Corrigenda

Installation Guide contain incorrect descriptions. Refer to the following table and confirm the descriptions that are corrected.

WV-X1571LN / WV-X1551LN / WV-X2571LN / WV-X2551LN / WV-S1572L / WV-S1552L / WV-S2572L / WV-S2552L / WV-X4573L / WV-S4551L / WV-X4573LM / WV-S4551LM

Processing the installation surface (process according to the installation type)

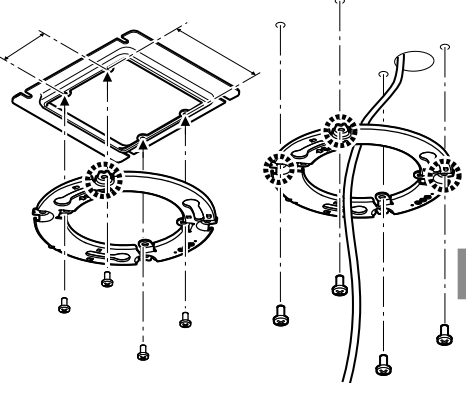
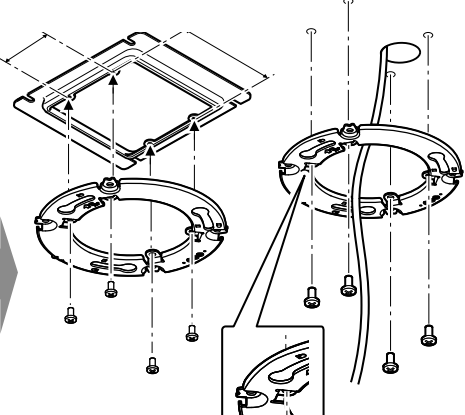
| Incorrect | Correct |
